RE: LU 22-07; Cate Street Development, LLC  
Supplemental Carport Submission; West End Yards Development Site  
Site Plan Review Application and Boundary Line Adjustment  
Fuss & O'Neill Reference No. 20180317.B10

The following letter is in support of a revised, supplemental, submission of plans depicting a slight layout revision to the covered carport parking along the railroad to the south of the West End Yards Development Site. The Cate Street Development Team has been working with Planning Staff on the Architecture of the Carports and has agreed upon design direction based on a rendering provided by Planning Staff.

# WEST END YARDS

## SITE PLANS

Rendering of Carports Provided by Planning Department (above)

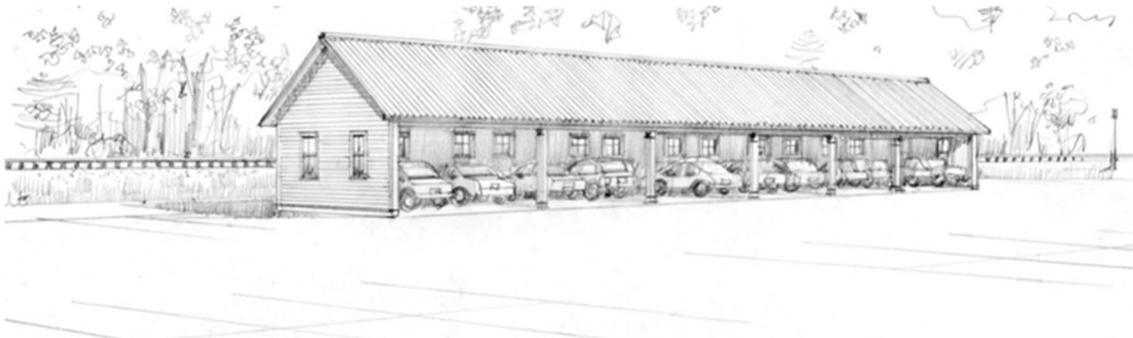
Cate Street Development has agreed to 2 carport structures for a total of 50 covered parking spaces. The Carports will be designed to match the Architecture in the above rendering.

The easternmost carport will provide 2 Handicap Accessible Spaces, 1 van accessible and 1 standard accessible space and 23 - 9-ft x 19-ft spaces. The overall dimensions of this structure will be 21-ft x 232-ft.

The western carport will provide 25 9-ft x 19-ft covered spaces. The overall dimensions of this structure will be 21-ft x 226-ft.
